LEARNING RESOURCES CENTER
BUILDING 'D' AND 'CR' REMODEL

VENTURA COLLEGE

September 24, 2001
KBZ Job No. 93-18

INSPECTOR COPY

3 South Elevation
 SCALE : 1/8" = 1'-0"

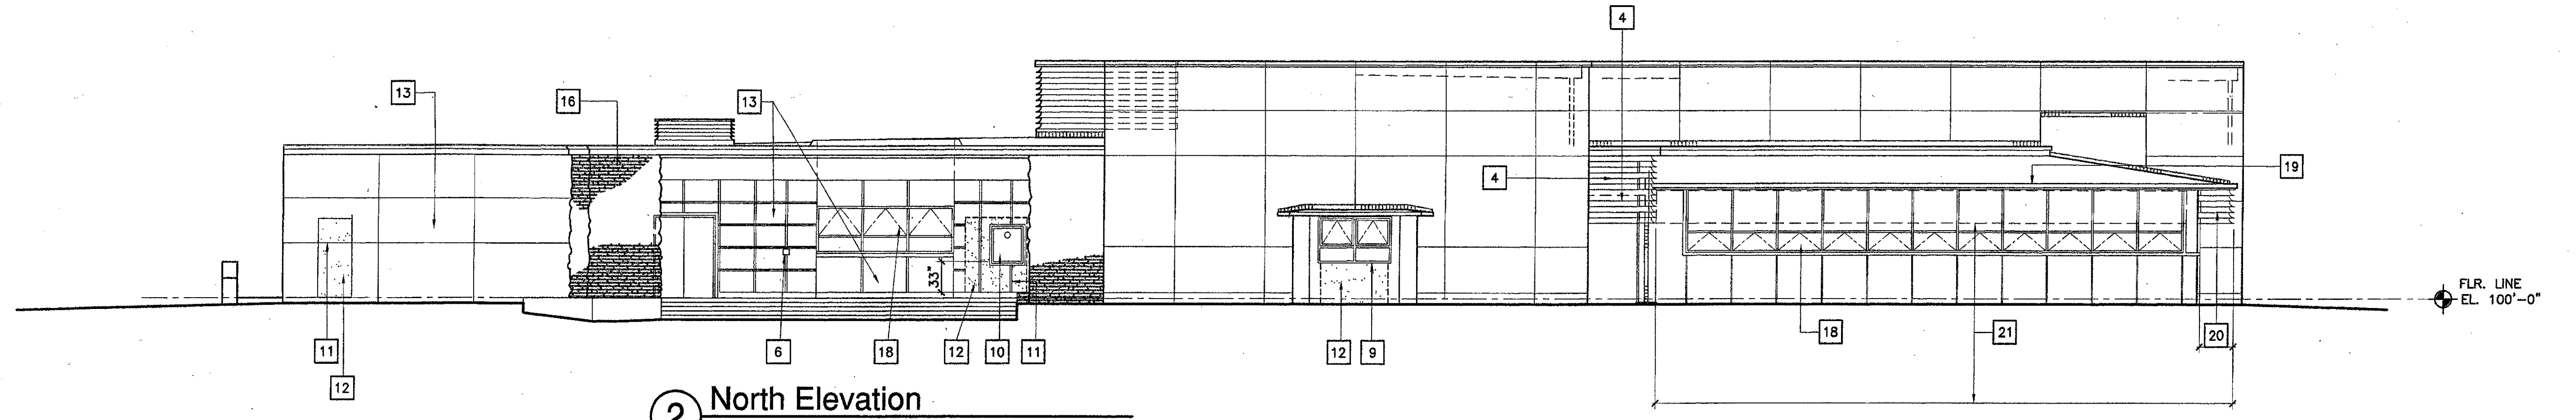
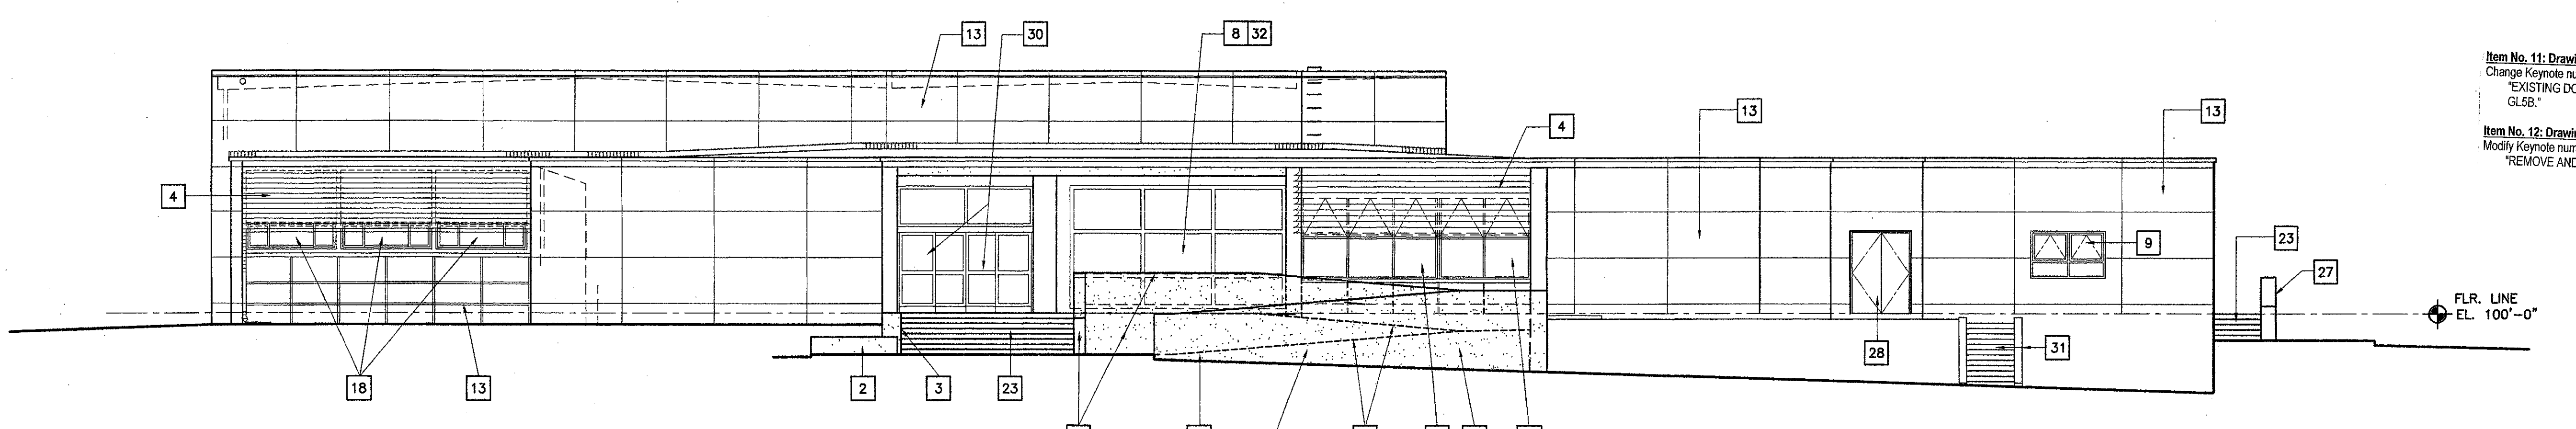
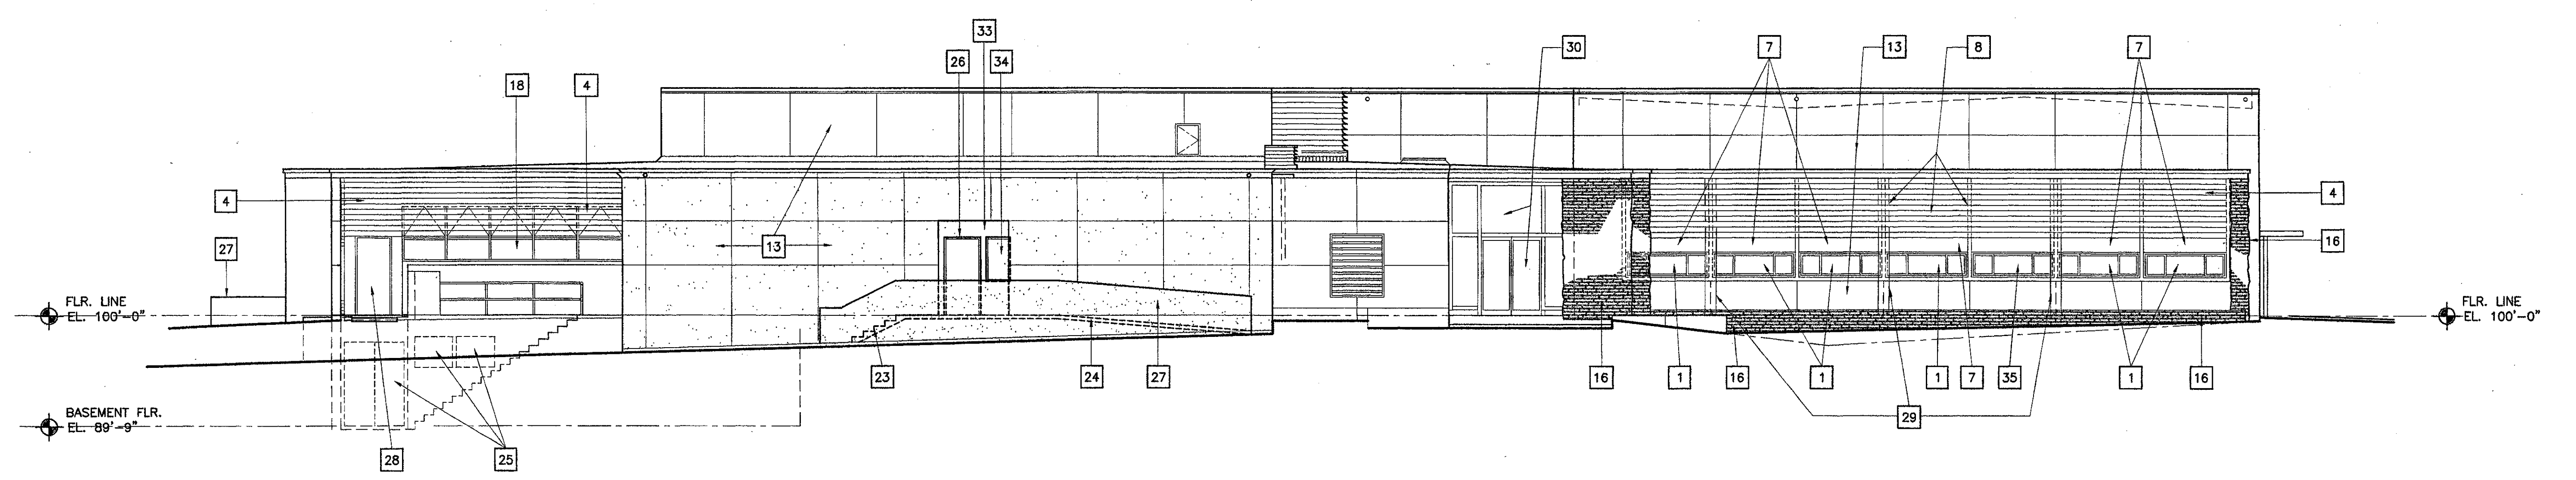
Item No. 11: Drawing Sheet A-201
 Change Keynote number 30 on Drawing number 3, South Elevation, to Keynote number 36 to read as follows:
 "EXISTING DOORS AND WINDOW WALL FRAME TO REMAIN. REMOVE AND REPLACE EXISTING GLASS WITH GLSB."

Item No. 12: Drawing Sheet A-201
 Modify Keynote number 32 to read as follows:
 "REMOVE AND REPLACE GLASS AT EXISTING ALUMINUM WINDOW TO REMAIN WITH GLSB."

2 Assessment Room 102
SCALE: 1/4" = 1'-0"

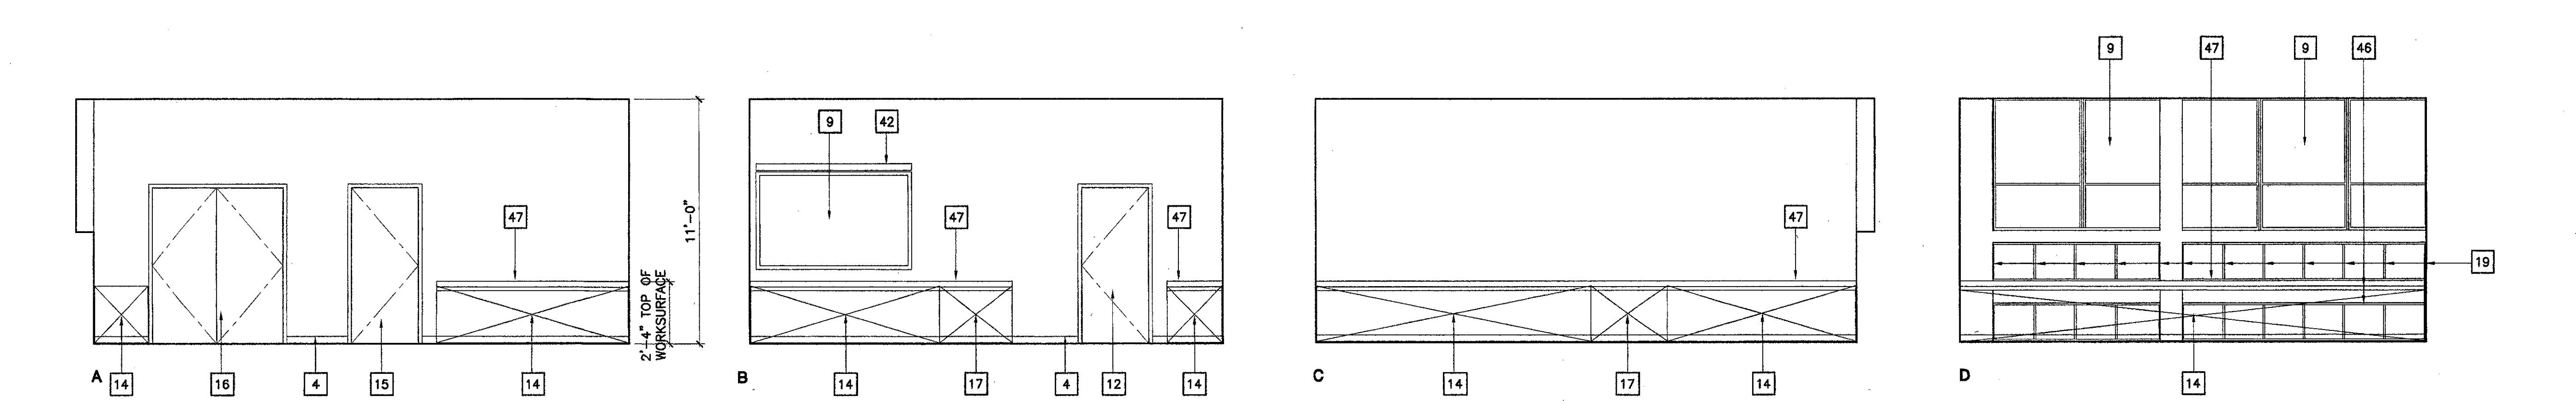
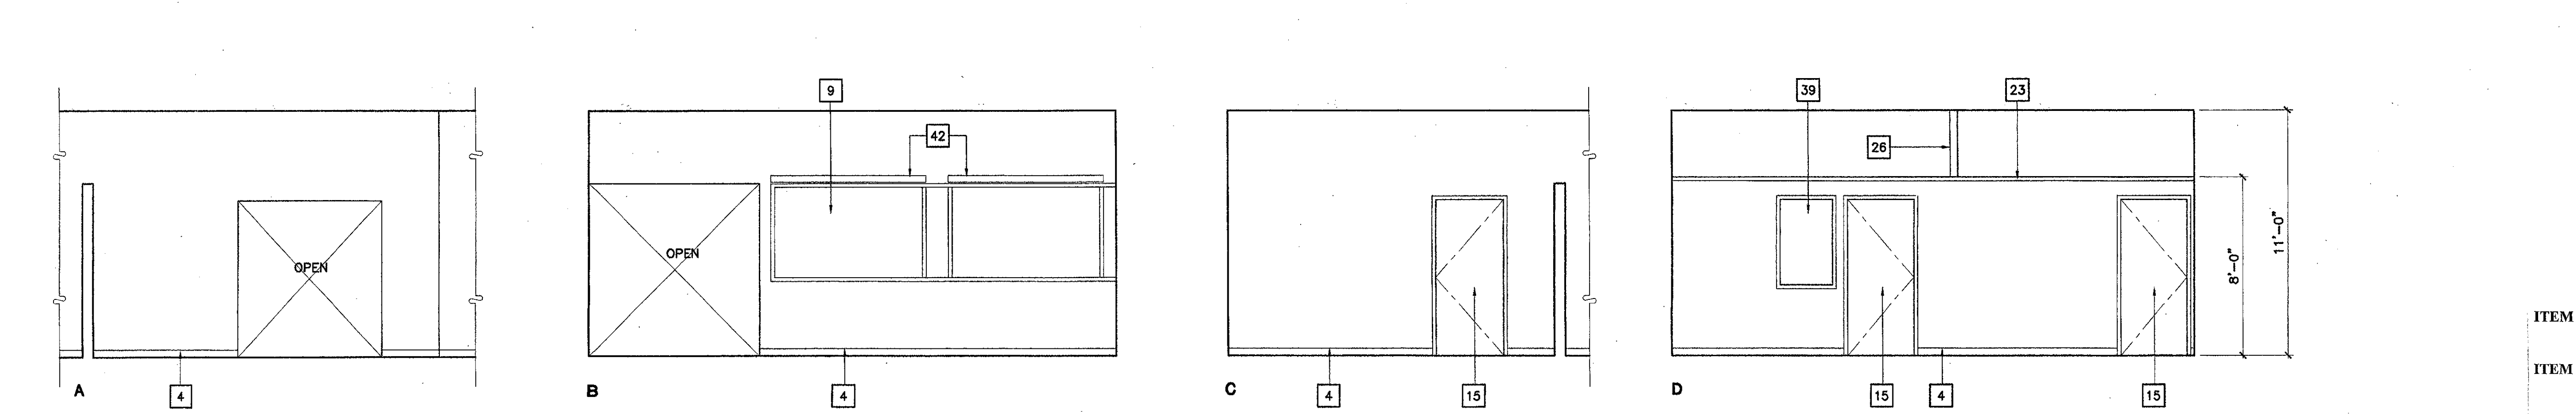
ITEM 24. Drawing Sheet A-402.
At 2 Assessment Room 102 Elevation change Keynote 19 reference to Keynote 48.

1 SKYLIGHT/SHAFT/CEILING FRAMING PLAN
SCALE: 1/2" = 1'-0"

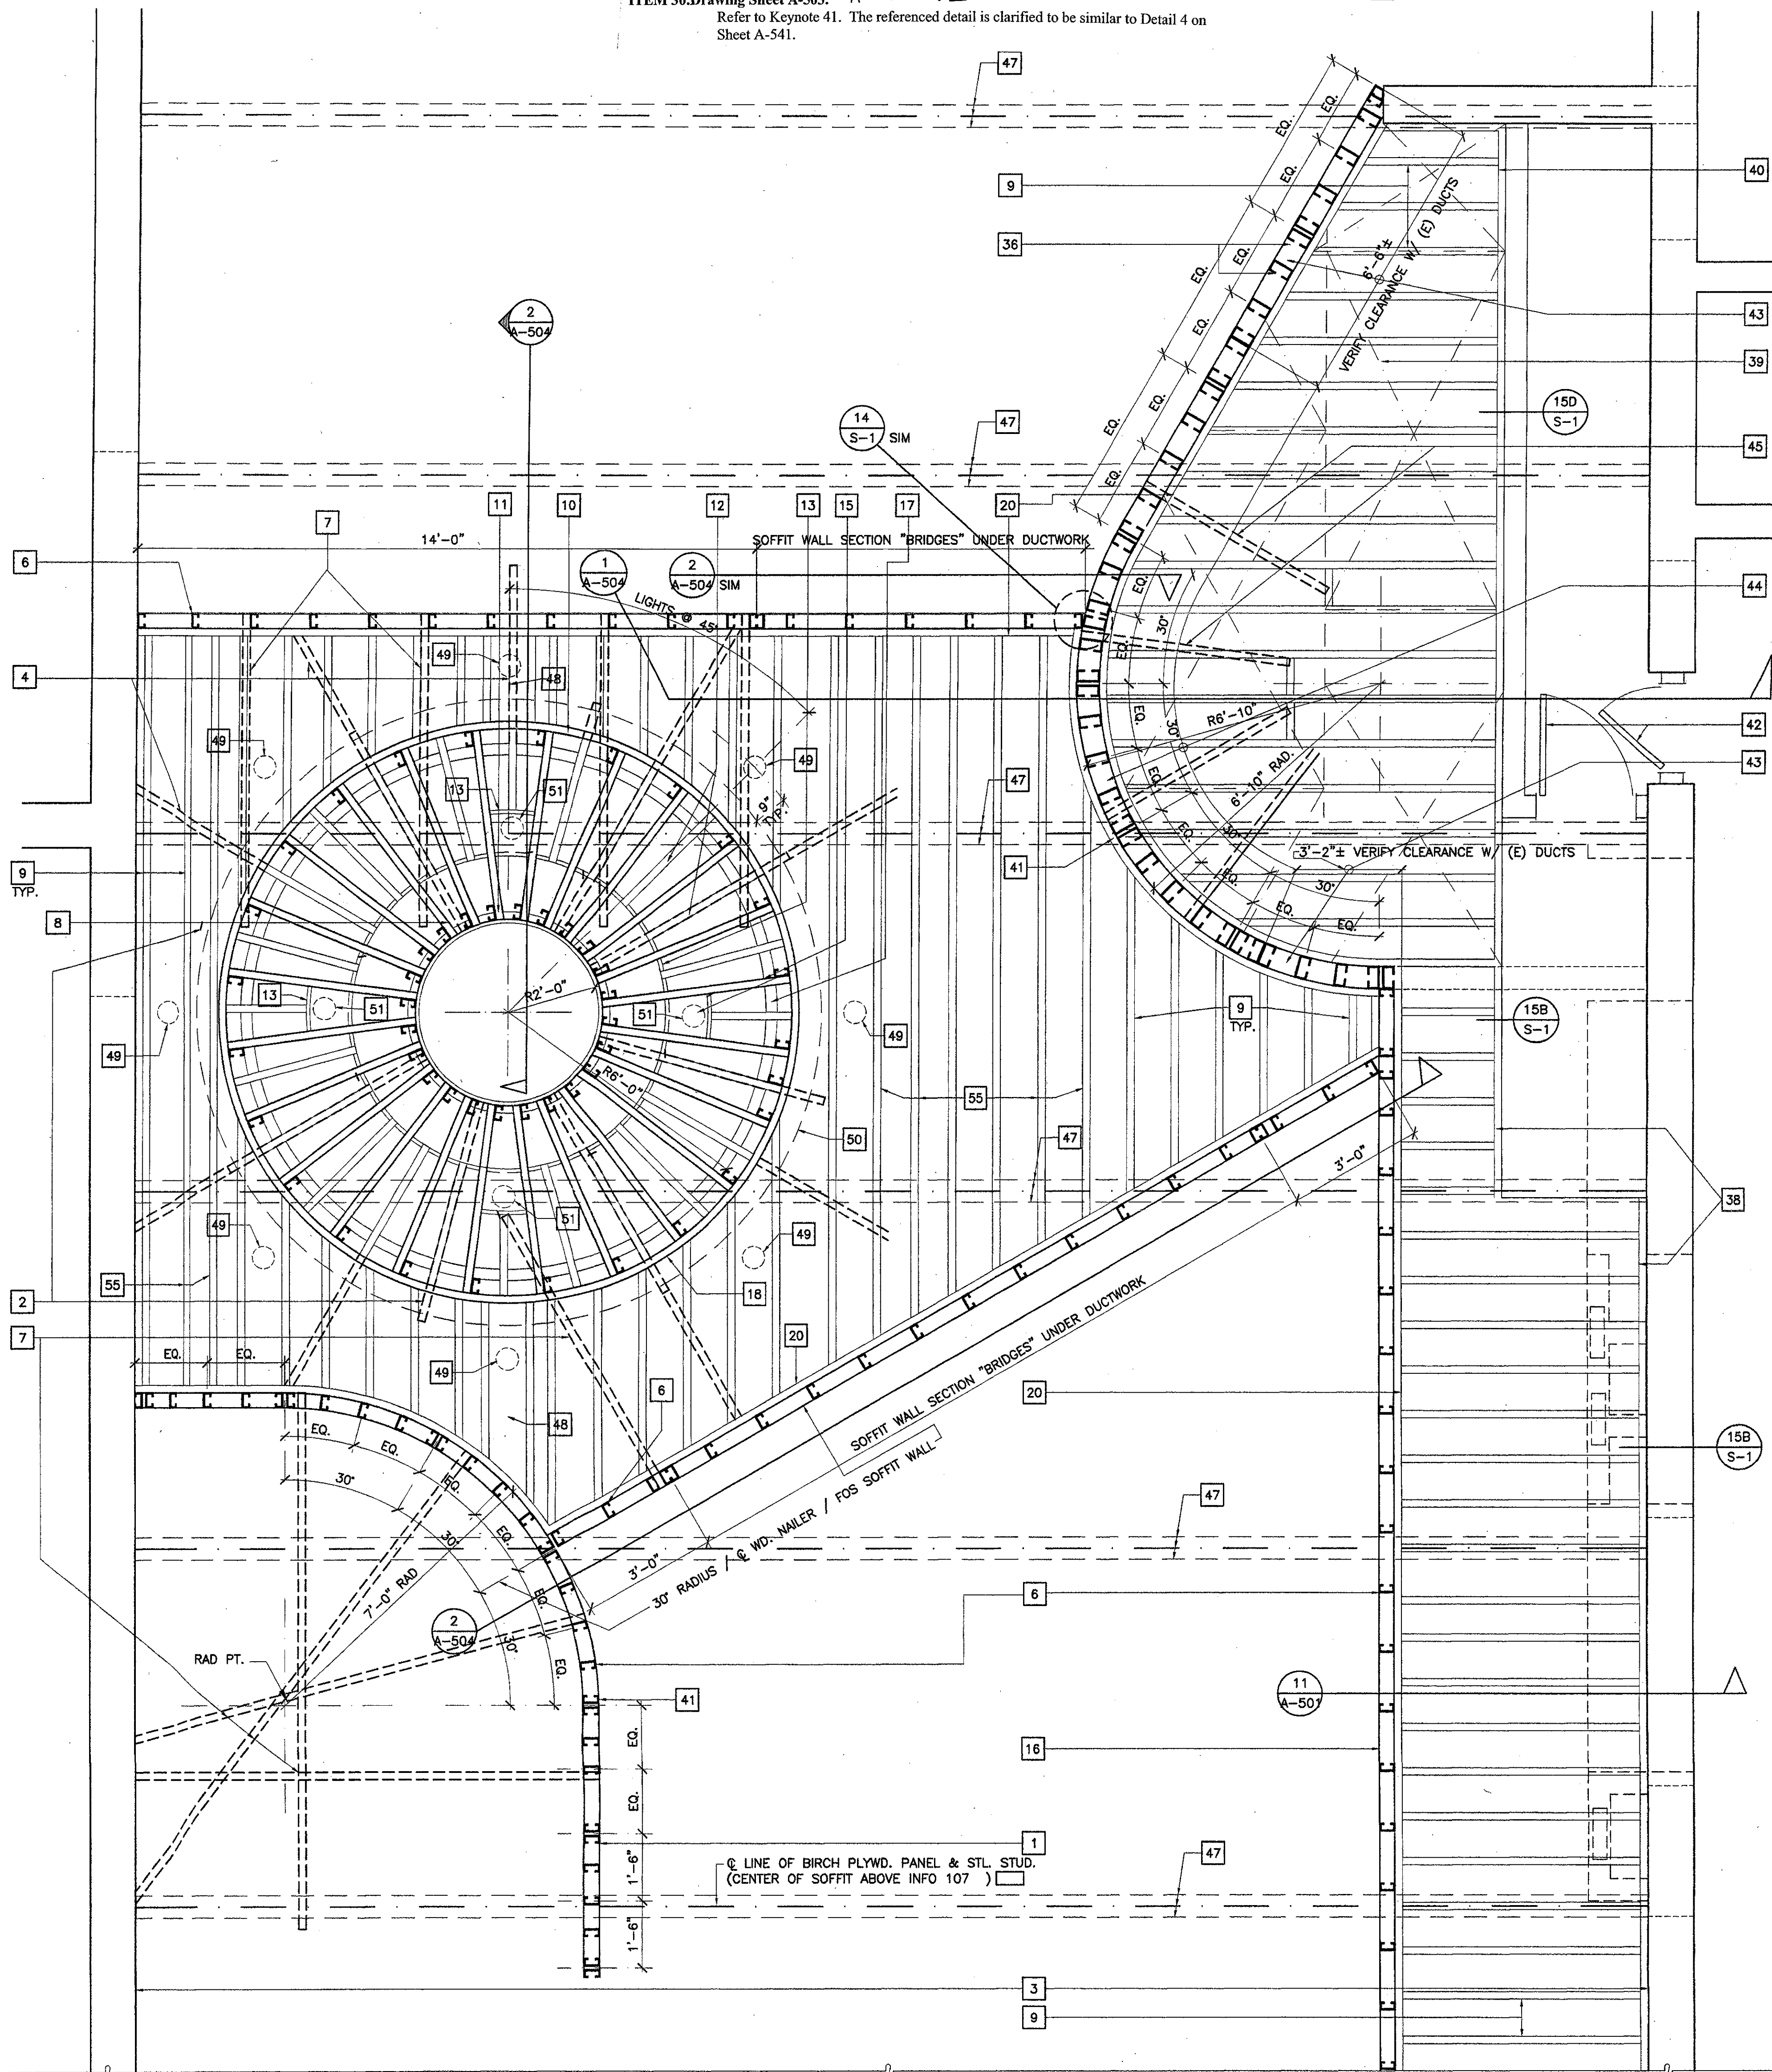
ITEM 30 Drawing Sheet A-503. APPENDUM 2.
Refer to Keynote 41. The referenced detail is clarified to be similar to Detail 4 on Sheet A-541.
